Wisconsin Department of Transportation

<p>Proposal #30: 7650-00-74, WISC 2021 044 C River Falls, South Main Street Culvert B-47-0230 STH 29 Pierce County</p>	<p>7650-01-74, WISC 2021 045 Prescott – River Falls USH 10 to South Junction CTH QQ STH 29 Pierce County</p>
<p>7650-01-75, WISC 2021 046 Prescott – River Falls CTH QQ S Jct to Cemetery Rd STH 29 Pierce County</p>	<p>7650-02-73, WISC 2021 047 Prescott – River Falls CTH FF & 770th Ave Intersection STH 29 Pierce County</p>

This is Addendum No. 01, which provides for the following:

ADDENDUM NO. 01
7650-00-74, 7650-01-74/75, & 7650-02-73
February 2, 2021

Figure 1: Nuclear/Core Correlation Location Layout

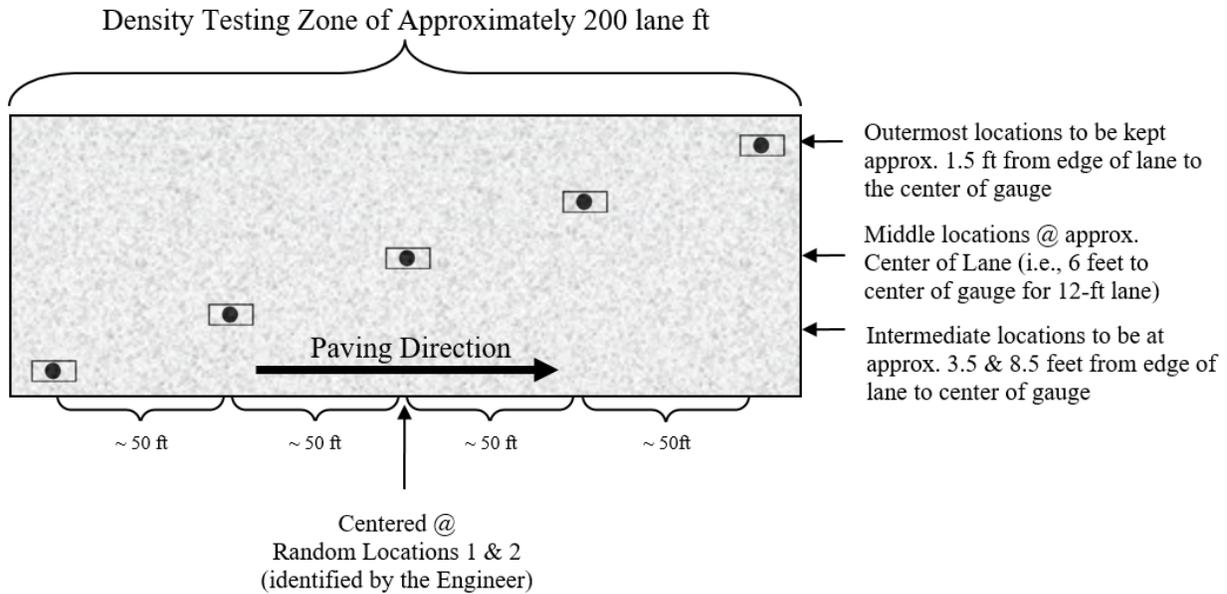
WisDOT Procedure for Nuclear Gauge/Core Correlation – Test Strip

The engineer will identify two zones in which gauge/core correlation is to be performed. These two zones will be randomly selected within each *half* of the test strip length. (Note: Density zones shall not overlap and must have a minimum of 100 feet between the two zones; therefore, random numbers may be shifted (evenly) in order to meet these criteria.) Each zone shall consist of five locations across the mat as identified in Figure 1. The following shall be determined at each of the five locations within both zones:

Individual locations are represented by the  symbol as seen in Figure 1 above. The symbol is two-part, comprised of the nuclear test locations and the location for coring the pavement, as distinguished here:

Each core 150 mm (6 inches) in diameter will be taken at locations as identified in Figure 1. Each random core will be full thickness of the layer being placed. The contractor is responsible for thoroughly drying cores obtained from the mat in accordance with ASTM D 7227 prior to using specimens for in-place density determination in accordance with AASHTO T 166 as modified by CMM 8-36.6.5.

Figure 4: Locations of main lane HMA density testing (QC=solid lines, QV=dashed)

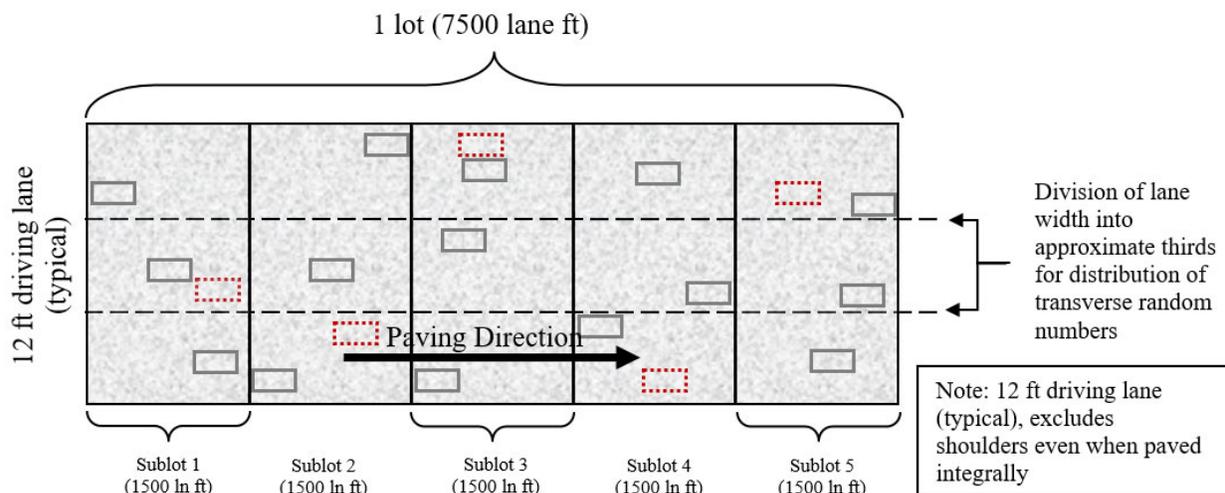
For nuclear density testing of the pavement beyond the test strip, QC tests will be completed at three locations per subplot, with a subplot defined as 1500 lane feet. The three locations will represent the outside, middle, and inside of the paving lane (i.e., the lane width will be divided into thirds as shown by the dashed longitudinal lines in Figure 3 and random numbers will be used to identify the specific transverse location within each third in accordance with CMM 8-15). Longitudinal locations within each subplot shall be determined with 3 independent random numbers. The PWL Density measurements do not include the shoulder and other appurtenances. Such areas are tested by the department and are not eligible for density incentive or disincentive. Each location will be measured with two one-minute gauge readings oriented 180 degrees from one another, in the same footprint as detailed in Figure 2 above. Each location requires a minimum of two readings per gauge. The density gauge orientation for the first test will be with the source rod towards the direction of paving. QV nuclear testing will consist of one randomly selected location per subplot. The QV is also comprised of two one-minute readings oriented 180 degrees from one another. For both QC and QV test locations, if the two readings exceed 1.0 pcf of one another, a third reading is conducted in the same orientation as the first reading. In this event, all three readings are averaged, the individual test reading of the three which falls farthest from the average value is discarded, and the average of the remaining two values is used to represent the location for the gauge. The subplot density testing layout is depicted in Figure 4, with QC test locations shown as solid lines and QV as dashed.

WisDOT Longitudinal Joint – Nuclear Gauge Density Layout

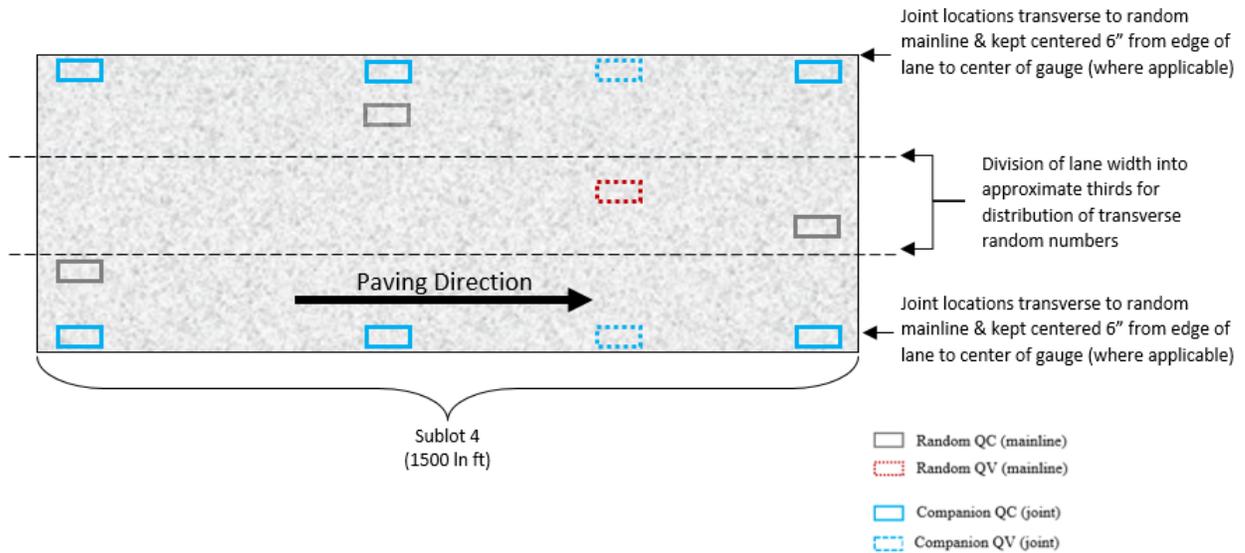
Each QC and QV density location must have a companion density location at any applicable joint. This companion location must share longitudinal stationing with each QC or QV density location and be located transversely with the center of the gauge 6-inches from the edge of the paving area.

For HMA Pavement Percent Within Limits QMP projects, this appears as follows:
